Access Compliance Report

Public Rights-of-Way

(Curb Ramps)

Main Street: BIMINI_DR Cross Street: CAMBERA_LN Location: W

ADA ID: RPRK211013132356 Ramp Type: Type 1 - Perpendicular Diagonal Initial Pass/Fail: Pass Overall Compliance: No Severity Score: 22

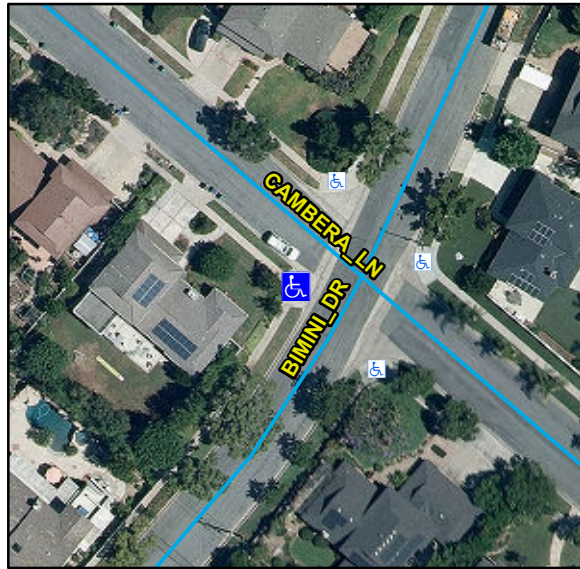
Compliance	Description	Data	Compliance	Description	Data
N/A	Ramp Length (in)	149	N/A	Flare Type LT	
Yes	Ramp Width (in)	49			Sloped
Yes	Ramp Run Slope (%)	4.5	N/A	Flare Slope LT (%)	7.1
No	Ramp Cross Slope (%)	2.6	N/A	Flare Traversable LT	No
N/A	Landing Present	No	N/A	Flare Type RT	
N/A	Landing Length (in)	N/A			Sloped
No	Landing Width (in)	N/A	N/A	Flare Slope RT (%)	0.7
No	Landing Run Slope (%)	N/A	N/A	Flare Traversable RT	No
No	Landing Cross Slope (%)	N/A	No	DWS Provided	No
N/A	Landing Movement Obstructed?	Yes	N/A	DWS Contrast	N/A
	Landing Movement Type	Wall	N/A	DWS Length (in)	N/A
N/A	Landing Shared	N/A	N/A	DWS Full Width	N/A
N/A	Clear Space	Yes	N/A	DWS Offset Left (in)	N/A
N/A	Clear Space To Crosswalk (in)	48	N/A	DWS Offset Right (in)	N/A
N/A	Marked Crosswalk 1	No	N/A	Marked Crosswalk 2	No
	Crossing 1 Direction	SE		Crossing 2 Direction	NE
	Marked Crosswalk 1 Width (in)	N/A		Marked Crosswalk 2 Width (in)	N/A

N/A	Ramp Inside Crosswalk 1	N/A	Yes	Ramp Inside Crosswalk 2	N/A
	Crossing 1 Slope (%)	1.6		Crossing 2 Slope (%)	1.4
	Crossing 1 Cross Slope (%)	3.5		Crossing 2 Cross Slope (%)	0.2
Yes	Gutter Ponding	No	N/A	Curb Slope	2.3
Yes	Gutter Lip Height (in)	0		Road Run Slope (%)	2.4
Yes	Gutter Run Slope (%)	1.4		Road Cross Slope (%)	2.1
Yes	Gutter Cross Slope (%)	1.4			
Yes	Overall Surface Condition: Acceptable		No	Perp Joint Present	No
	Cross Gutter Present?	Yes		Spandrel Present?	Yes
	Replace Cross Gutter?	No		Replace Spandrel?	No

Remove & Replace Curb Ramp With Two New Directional Ramps or Equivalent.
